SUNDRY NOTICES AND REPORTS ON WELLS

Delaware Basin Changes to APD for Federal Well

Summery of Changes to APD Submission

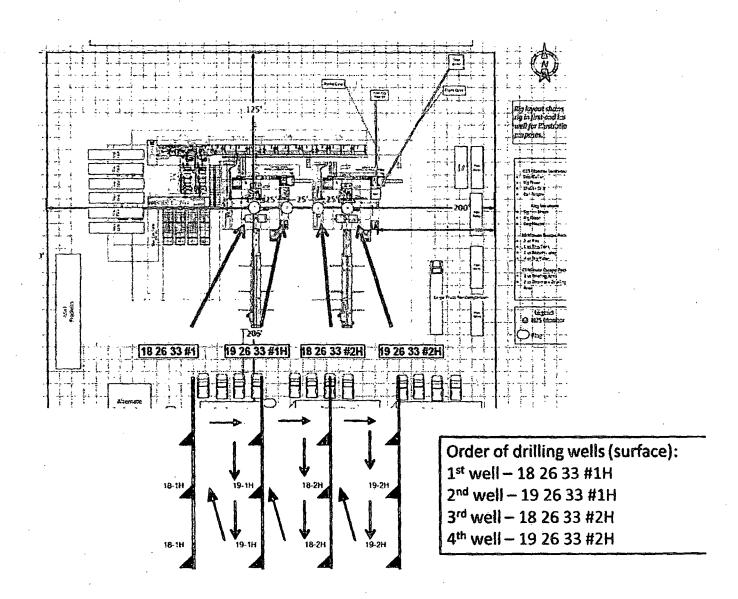
- Surface Hole:
 - 1. Drill 17-1/2" surface hole with fresh water to planned casing set depth with 10' rat hole.
 - 2. Run casing as stated by approved APD, land out wellhead, and cement.
 - 3. Dress out 13-5/8" 5M SH-2 wellhead and install/secure with temporary abandonment cap, and a pressure gauge will be installed. Reference image below Part # 399984
 - 4. Skid to next well according to below "Drill Order"

Batch Dilling Sequence

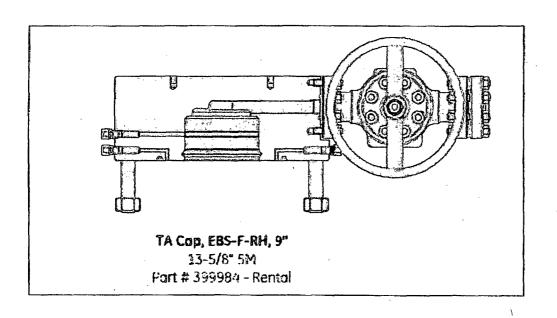
Chevron respectfully request the ability to batch drill in the SALADO DRAW (18-19) 26 33 PAD (3^{RO}). The summary provided below is a brief description of the main operational sequences for drilling and casing off the four wells listed above.

Summary: Variance to batch drill the Salado Draw pad not requested in original submittal.

Chevron respectfully request the ability to batch drill in the SALADO DRAW (18-19) 26 33 PAD (3RD). The summary provided is a brief description of the main operational sequences for drilling and casing the four wells listed.

- Once the Rig is on location, it will drill the above mentioned wells in conjunction using batch drilling.
- BOP/BOPE test to be conducted per Onshore Oil and Gas Order No. 2 as soon as the Rig is rigged up on well and each time the BOP/BOPE is nippled up. CIT for all casing shall be performed and results recorded on subsequent sundry.

- 4. Minimum working pressure of the blowout preventer (BOP) and related equipment (BOPE) required for drilling below the surface casing shoe shall be 5000 (5M) psi. 5M system requires an HCR valve, remote kill line and annular to match. The remote kill line is to be installed prior to testing the system and tested to stack pressure. BOP/BOPE shall be tested after nipple up according to Onshore Order #2.
